## > Product Change Notification (PCN)

Product group: **MINISKIIP, MINISKIIP II**

No.: PN21-048 **Standard and slim pressure lids**

24 Jun 2021

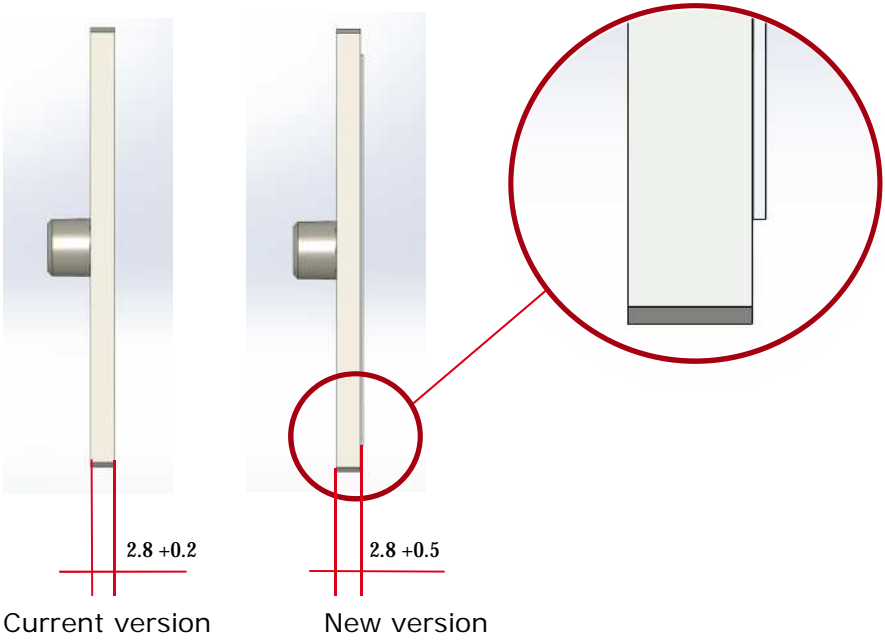
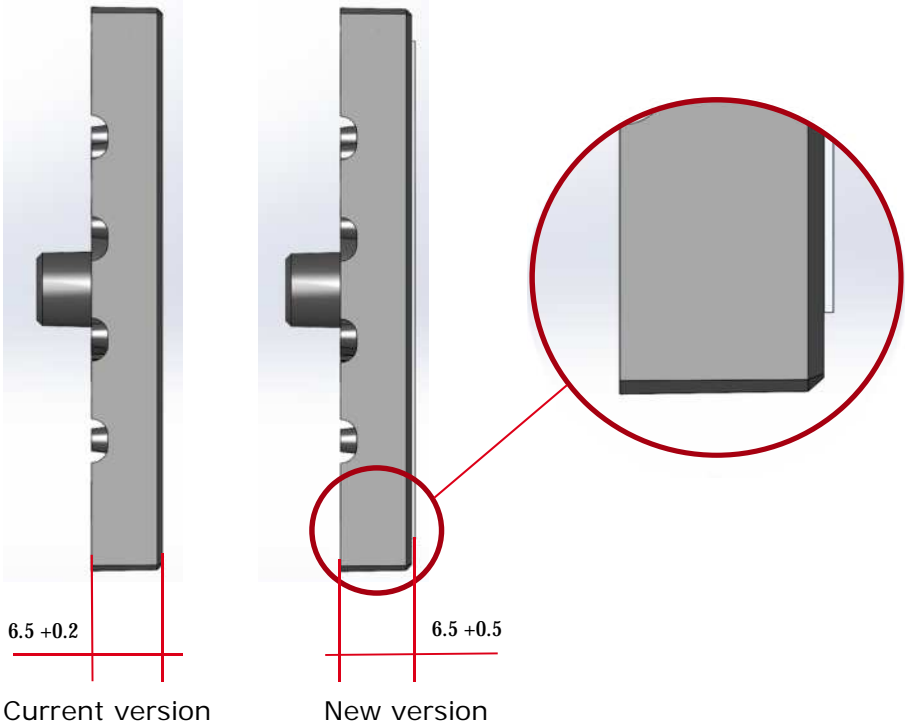
Subject of change: Maximum height of pressure lids

Description of change: Change of the maximum height tolerance (from +0.2mm to +0.5mm) of MiniSKiiP size 0-3 standard and slim lids (caused by metal inlay thickness tolerance)

Impact of change: Maximum height of the lids (worst case +0.3mm)
